TCEQ DAM SAFETY
Field Operations Support Division

Dam Evaluation Report

Hearn Dam

TX09407

Photo 11 - Void beneath the concrete right spillway. Note the rectangular pattern of what looks to be exposed rebar.

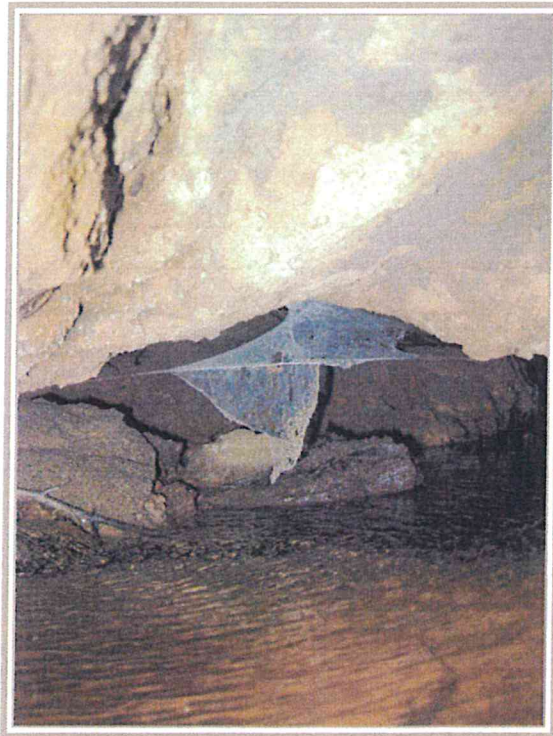
- Photo 10 shows the area to the right of the lower end of the concrete.
- What appeared to be a rather extensive void was found beneath the concrete of the lower section of the concrete spillway. Photos 11 shows what appears to be the reinforcing rod exposed at the bottom of the concrete slab. And in another nearby location, Photo 12 shows another void or perhaps the same void approximately 25 feet further upstream from the location of Photo 11.

2. It is strongly recommended that the voids under the concrete spillway be immediately addressed. A professional engineer should be consulted for feasible solutions to this condition. Support for the concrete will eventually not be enough, and the spillway will collapse. This repair will be more effective if proper spillway sizing is taken into account by your engineer (see Rec. #10).
